§	UN R100 series 02	Outcome RESS-9	Comments
1.2	<p>[Part II: safety requirements with respect to the Rechargeable Energy Storage System (REESS), of road vehicles of categories M and N equipped with one or more traction motors operated by electric power and not permanently connected to the grid. Part II of this Regulation does not apply to REESS(s) whose primary use is to supply power for starting the engine and/or lighting and/or other vehicle auxiliaries systems.]</p>		<p>Has to be discussed at the end because a separate UN R for category L maybe a result.</p>

§	UN R100 series 02	Outcome RESS-9	Comments
6.	<b>Part II: Requirements of a Rechargeable Energy Storage System (REESS) with regard to its safety</b>		
6.1	<b>General</b>  The procedures prescribed in Annex 8 of this Regulation shall be applied.

Figure 1  
Generic description of test pulses

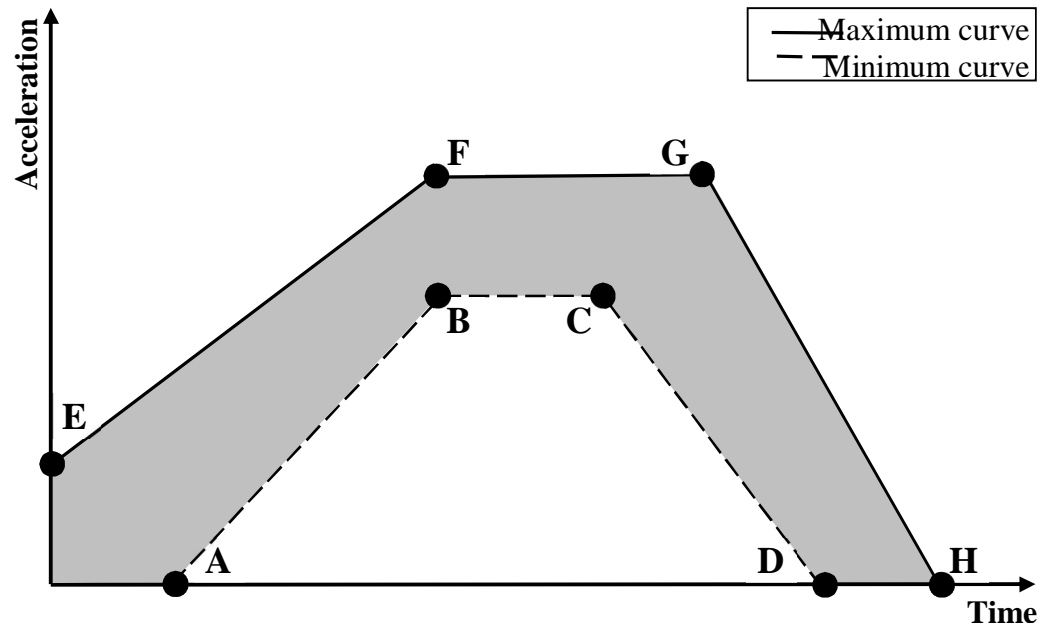
**Annex 8 C => Proposal from IMMA based on ISO 18243 for vehicle + REESS or only REESS**

Figure 7

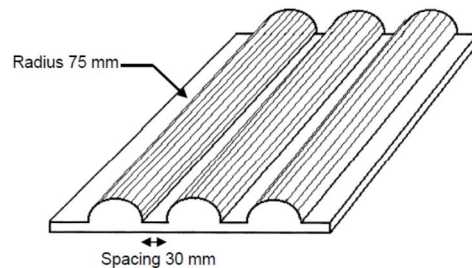
Annex 8 D => see Annex C for category L

Figure 1  
Phase A: Pre-heating

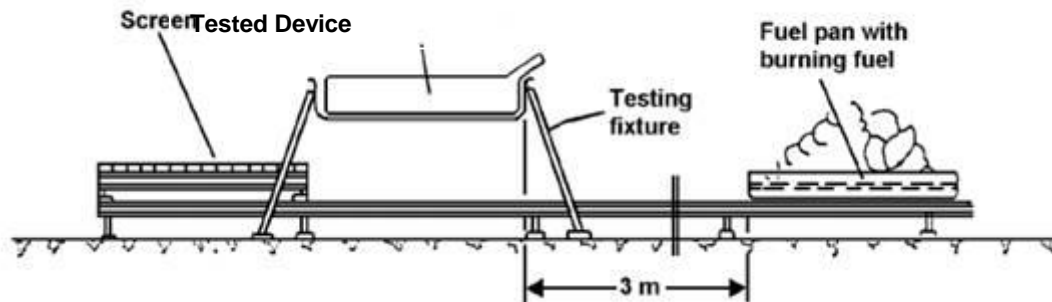
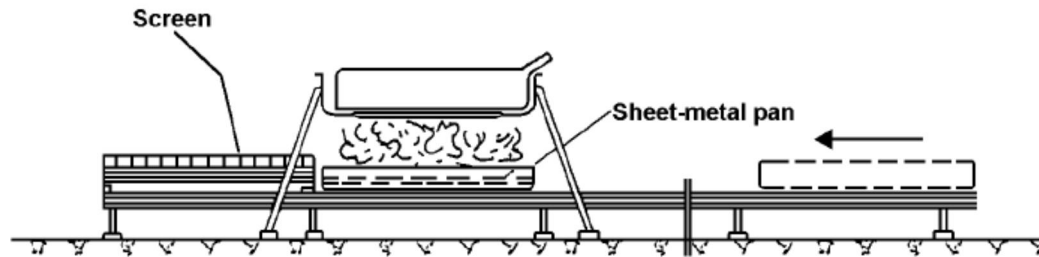
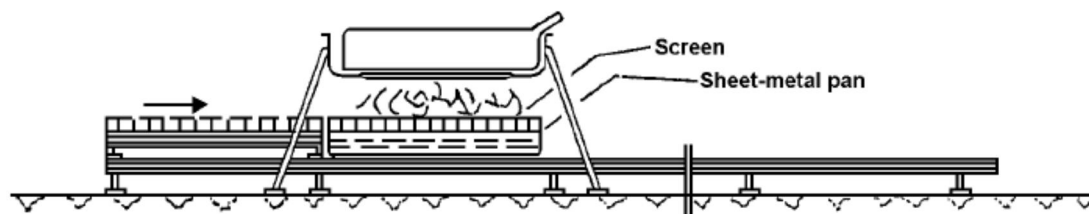
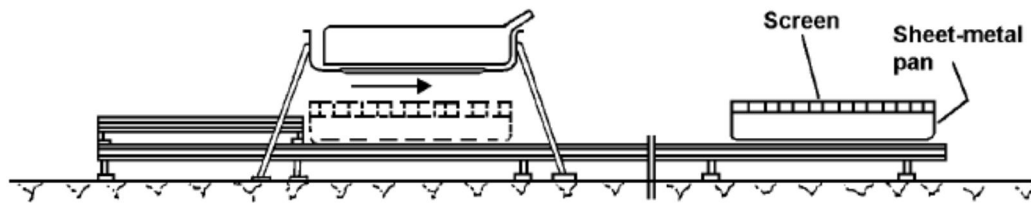
**Annex 8 E => L- Vehicles without passenger compartment should be excluded from the fire resistance because:**

- **During an accident it is very likely that the rider and the vehicle will be separated**
- **If the rider and the vehicle are not separated the rider is directly exposed to the fire. The rider is not protected by the surroundings of the vehicle against the fire. Only if a passenger compartment is there it makes sense to require a fire resistance REESS to give the occupants time to be evacuated out of the vehicle.**
- **If the rider needs time to leave the vehicle the fire under the vehicle would be the rider's first concern**
